1 Products affected

Product Change Notification					PCN 4797 Approval Marking		
owner	creation date	release date	released by	change order no	rev	page	D10-023-983
vetersa	07.03.2018	27.03.2018	limachcl	2014860	A	1 of 2

Old product appearance	New product appearance

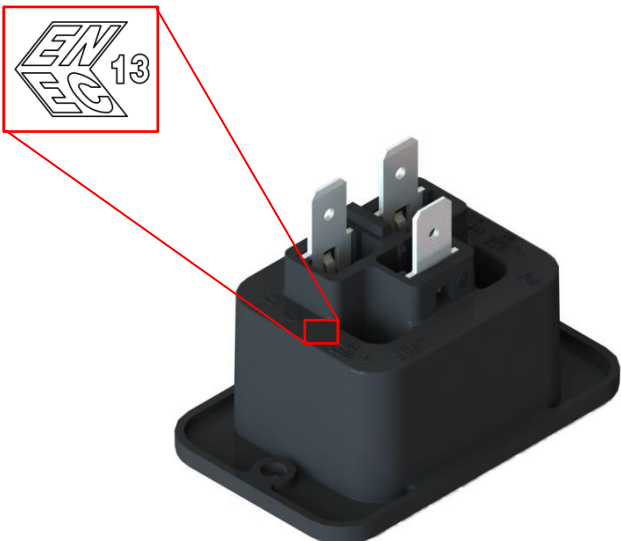
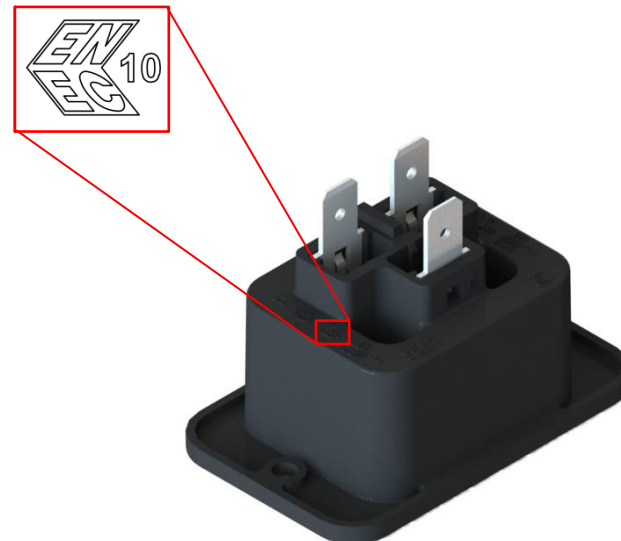
The european approval Institute has changed from SEV to VDE. As consequence the approval sign will be changed from ENEC13 to ENEC10 on the Appliance Outlets 4797 and on the label.

Old product approval ENEC13 (SEV)	New product approval ENEC10 (VDE)
--------------------------------------	--------------------------------------

Old label	New label

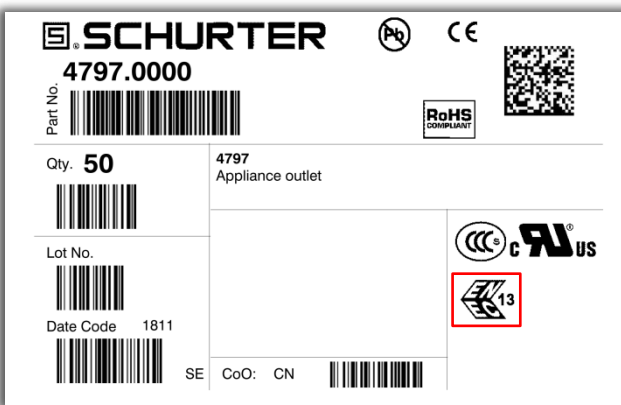
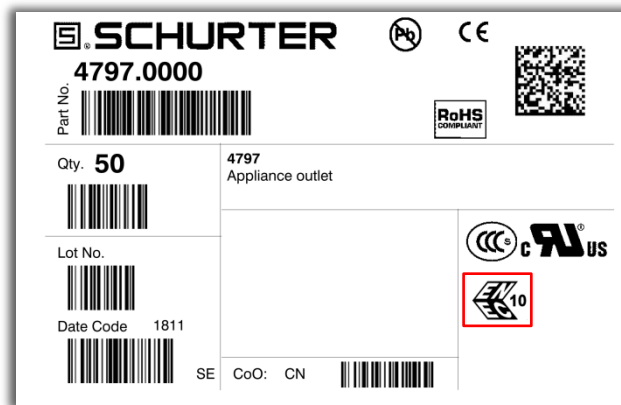
Form	Yes	Approval sign: ENEC10 instead of ENEC13
Fit	No	No change for dimension
Function	No	No change in function
Manufacturing	No	No change for manufacturing site
Label	Yes	Approval sign: ENEC10 instead of ENEC13
Packaging	No	No change in packaging
